Re: Redevelopment proposal at 430 W. Dayton St.

RE: Interpretation of Accessory building for project at 430 W. Dayton St.

Date: April 12, 2010
To: Plan Commission
From: Matt Tucker, Zoning Administrator
Subject: 430 W. Dayton Street

First Floor Plan - 784 GSF

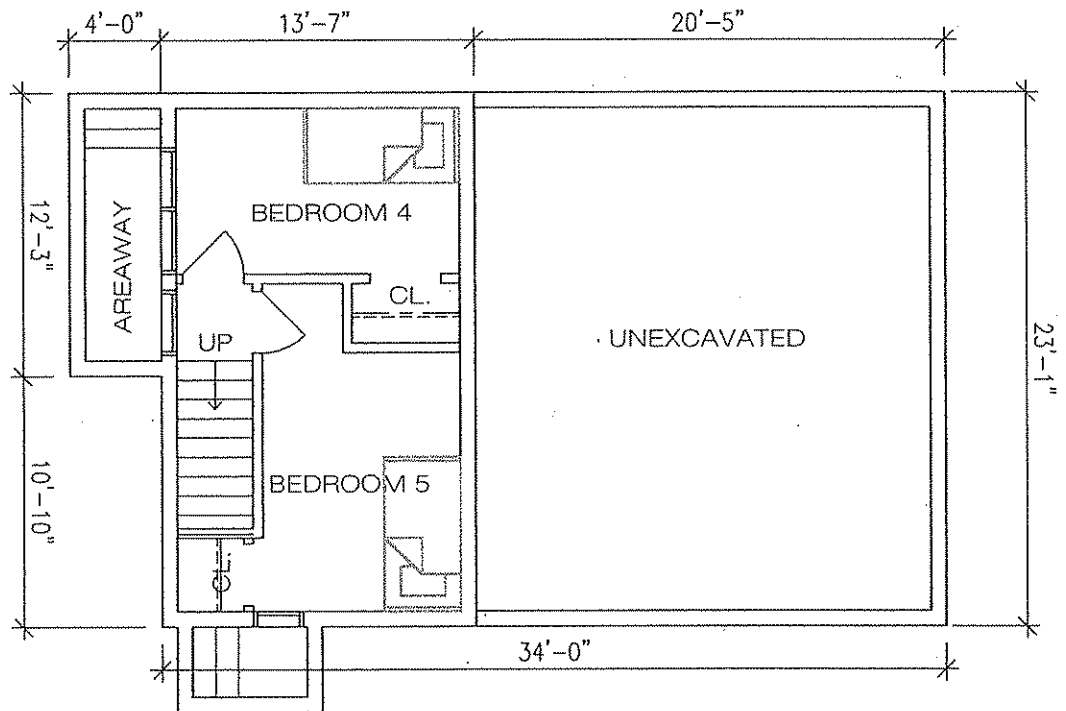
- The “accessory” use component of the structure is located on the first story (about 690 sq. ft.) of a four level structure (approx. 2,342 gross sq. ft.), which results in about 30% of the gross square footage of the structure devoted to “accessory” use.
- The dwelling unit comprises the majority of the floor area of the structure.
- The structure qualifies as a two story structure, with the dwelling unit spans four levels of the structure:
 - Two bedrooms and a half bath in the basement (1st level),
 - First floor stairwell (2nd level),
 - Three bedrooms, full bath, kitchen in second floor, deck (3rd level),
 - Living room and stair that qualify as a “loft” space in the area above the second story (4th level).

The proposed project includes a single, large dwelling unit. Typically, the dwelling unit would be found on the level above a garage or storage area, with a stair for access. The size of the dwelling unit is typically limited by the size of the floor plate below. Past approval history for this type of building has shown that accessory buildings that contain dwelling units typically are comprised of first story garage/accessory space, with dwelling space added to the second level of the structure, either under gabled roof or as a full second story.
